File Number	PL 19-018	Contact	Steven Robertson	
Type	MU-I Planning Review	Planning Commission Date	May 29, 2019	
Deadline for Action	Application Date	April 24, 2019*	60 Days	June 23, 2019
	Date Extension Letter Mailed	May 21, 2019	120 Days	August 22, 2019
Location of Subject				
Applicant	Essentia Health	Contact	Scot Ramsey, Vice President Facilities	
Agent	LHB	Contact	Evan Aljoe, Healthcare Studio Lead	
Legal Description	See Attached			
Site Visit Date	May 11, 2019	Sign Notice Date	May 15, 2019	
Neighbor Letter Date	May 14, 2019	Number of Letters Sent	243

DATE: May 22, 2019
TO: Planning Commission
FROM: Steven Robertson, Senior Planner
SUBJECT: Essentia Health's Vision Northland MU-I Planning Review

Essentia Health is proposing a new hospital that will include new inpatient and outpatient facilities adjacent to the existing St. Mary Medical Center. It will be located at the intersection of East 2nd Street and North 4th Avenue. The 940,000 gross square foot project consists of 18 levels on a sloping site, starting with level 1 on Superior Street and level 6 on East Second Street. It will provide 312 patient beds (one bed per room), outpatient clinics, and includes a rooftop helip

BUS SHELTER & BIKE PARKING LOCATIONS

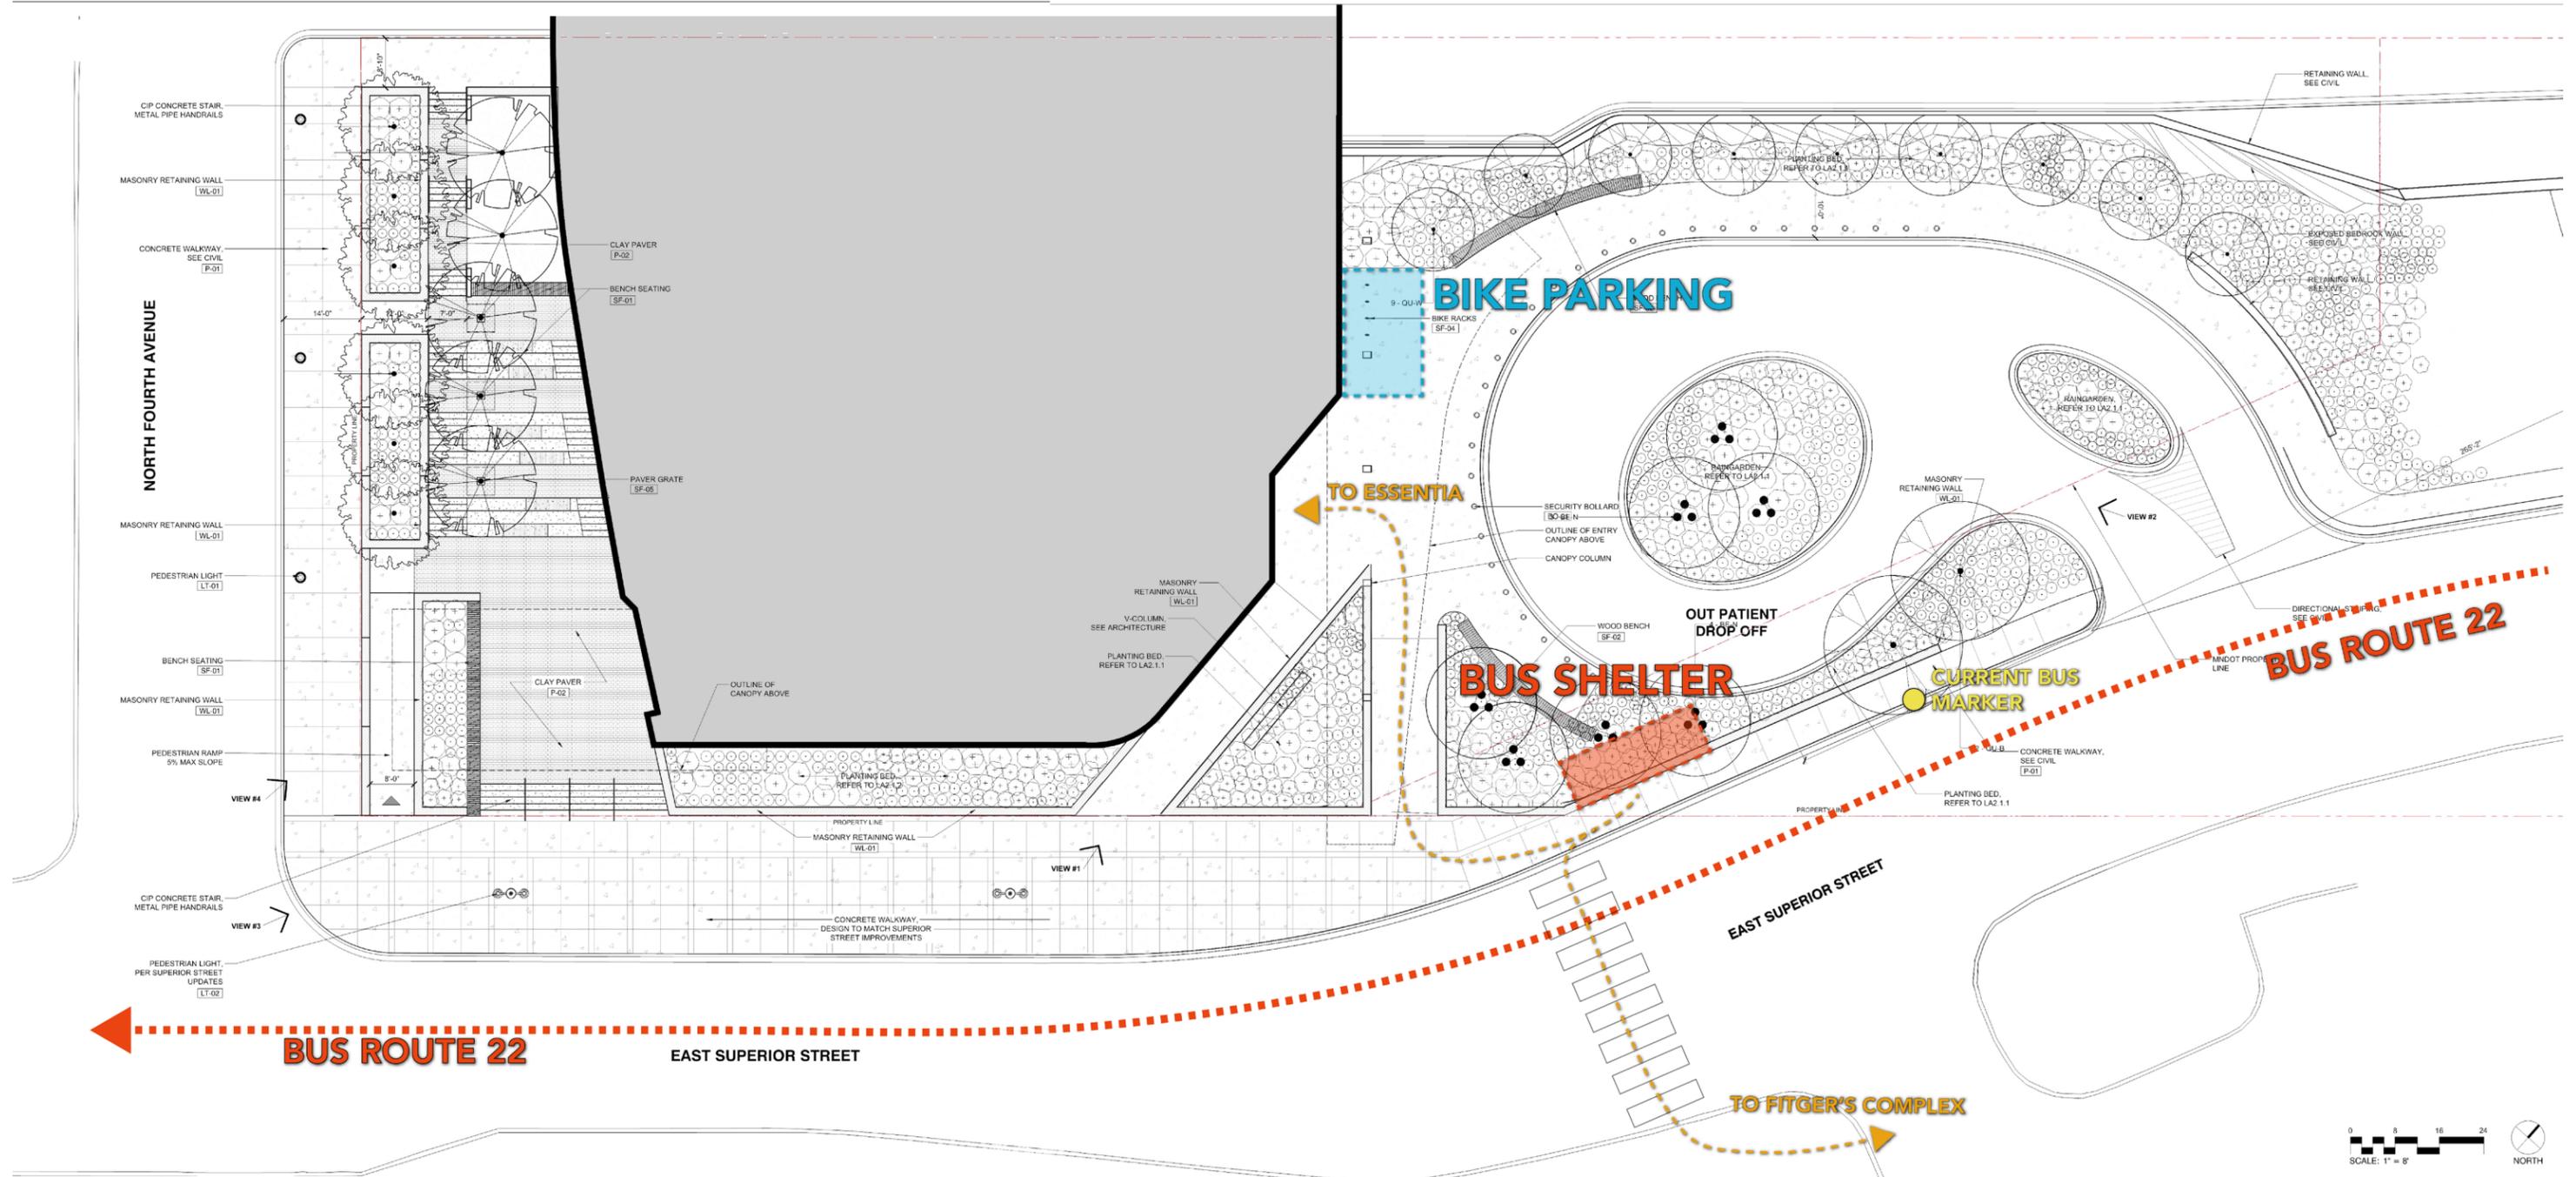
- Bike parking at 2nd Street building entry should be relocated from Skywalk pillars to next to or near to major building entry points, both for new hospital building and the existing building. Bike parking at Superior Street building entry. In addition to the planned bike parking at the drop-off entrance, bike parking should also be placed at the building entry point closer to 4th Ave East and Superior Street, particularly under the canopy roof. If concerned about too many bike racks, create room to easily add more if needed. (Similar to what the Duluth Public Library did when they installed their bike racks, they started with three, and then added more as needed).

- 7) Increase the number of bike racks to provide the capacity for at least 80 bicycles;
- 8) Amend the location and size of the proposed bus shelters in collaboration with the Duluth Transit Authority;

EAST SECOND STREET

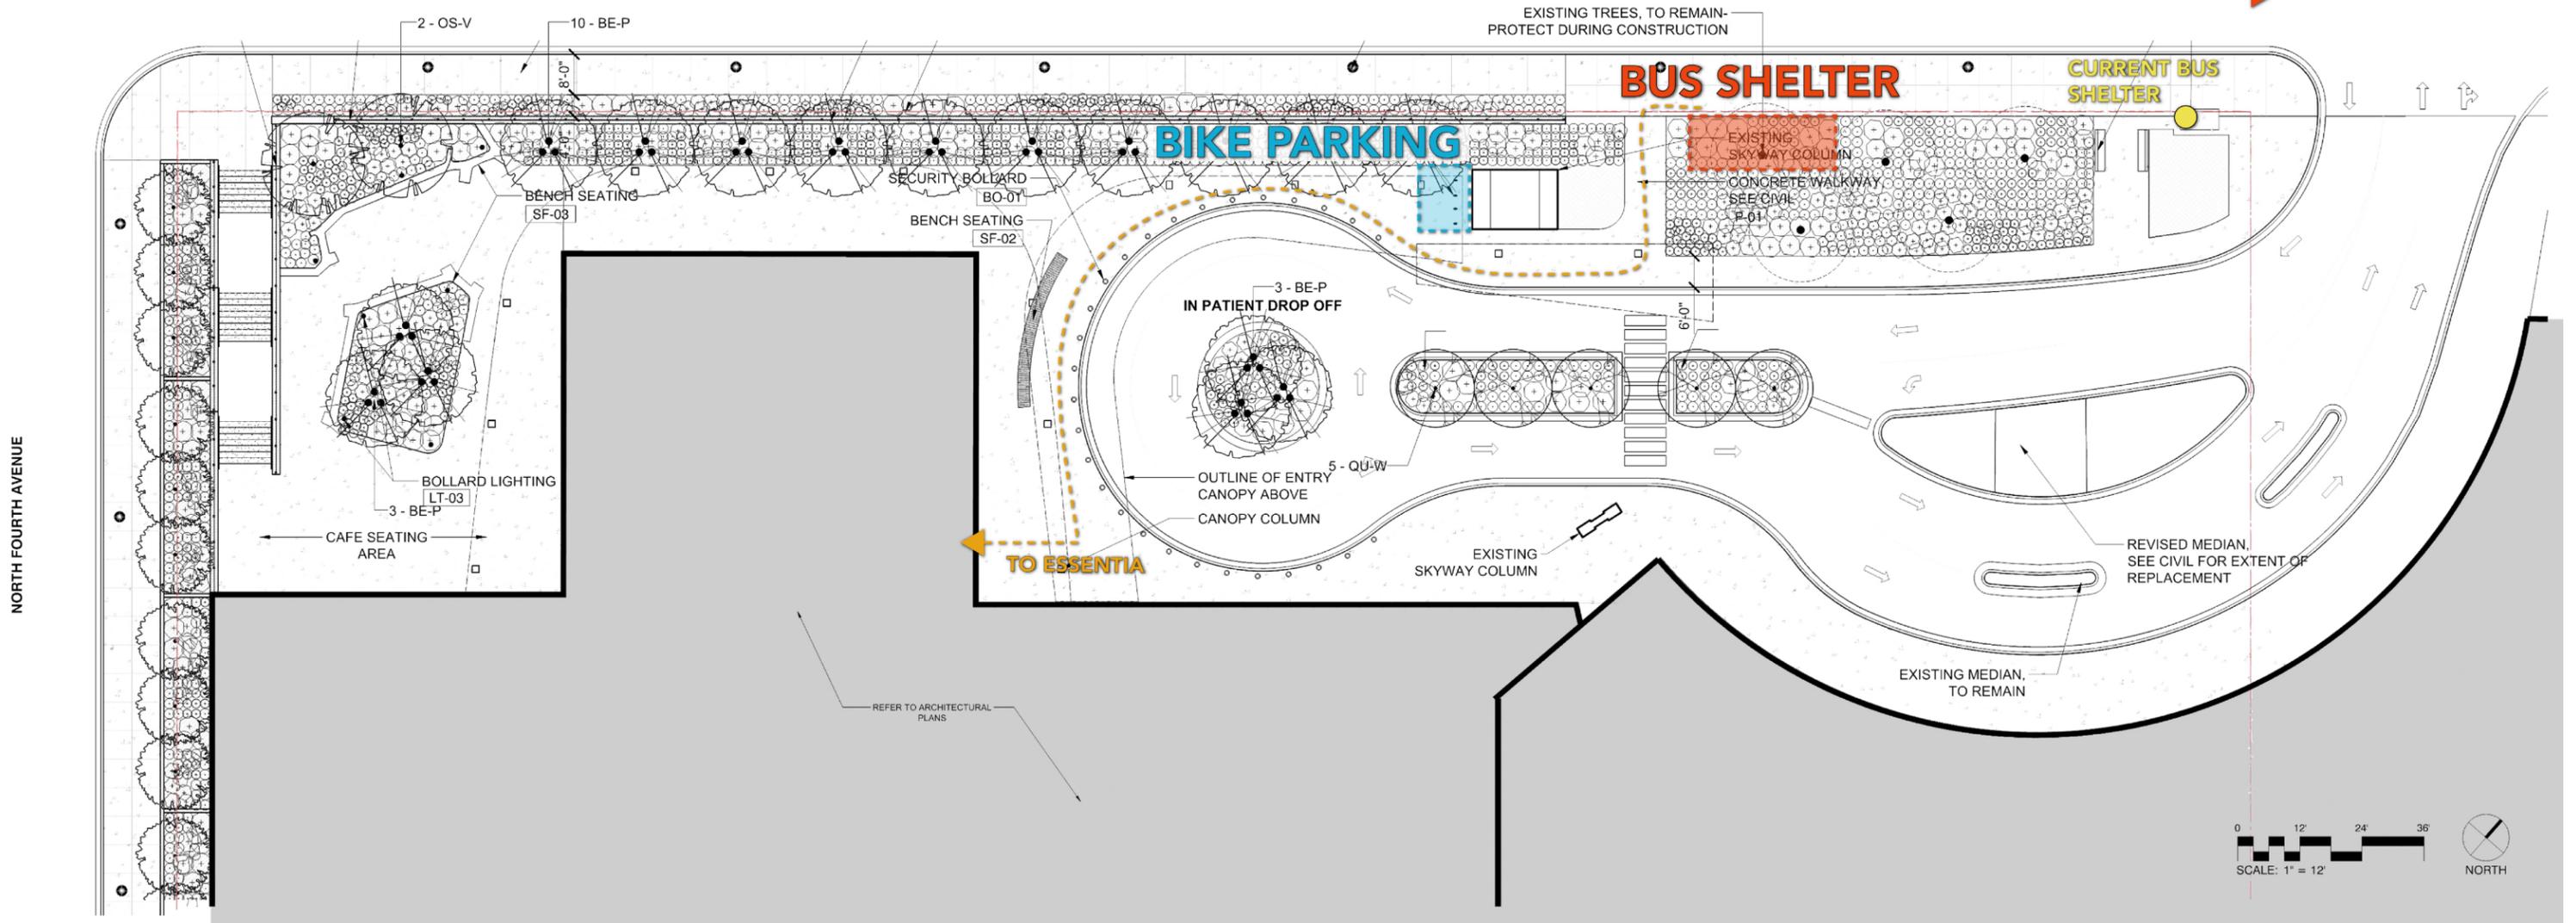
-Staff from Engineering (Transportation) stated that the offset driveway on Superior Street (across from Fitgers) is not appropriate as designed; they should line up with each other. As designed, it presents more conflicts and movements that drivers have to figure out and watch for when trying to exit, especially on a curve where sight distance is already tough and there is a RRFB (Rectangular Rapid Flash Beacon). It was also pointed out that the landscape plans listed the RRFB as a proposed addition, when it is in fact a present condition. Also, it is unclear what is being proposed for the new pedestrian crosswalk improvements.

- 9) Change the proposed vehicle driveway access on Superior Street to either line up with the existing access for the Fitger's public parking ramp;
- 10) Revise the vehicle driveway access on Superior and East Second Street to reduce their width to not exceed the maximum recommend width for commercial or industrial uses in an urban area (2014 Duluth City Engineering Specifications and Standard is 26 feet);
